Assembly Alert: 183

Subject: Relieve cut in wing root ribs

Models Affected: All 141 wings under construction.

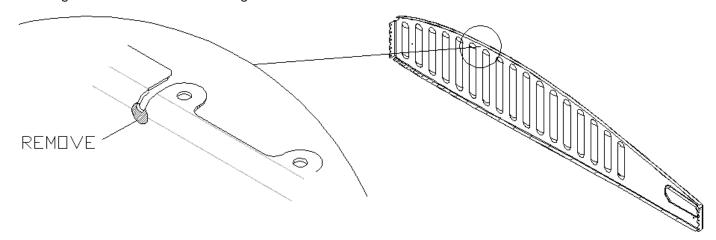
It has come to our attention that the relief next to the micro flange on the top front section of the wing root ribs is inadequate and causes cracking during the forming process.

The parts that require inspection and modification are KPWI0639 and KPWI0640.

Each builder should inspect the root ribs. Use a 3/16" to 1/4" drill bit to remove material as shown. Deburr and remove more material as necessary to remove any visible cracks. If the top skin is already riveted to the ribs, the problem area on KPWI0640 can be inspected and repaired through the root of the wing after removing the inside root rib and wing tank.

The design of the root ribs has changed and all future kits will not have this issue.
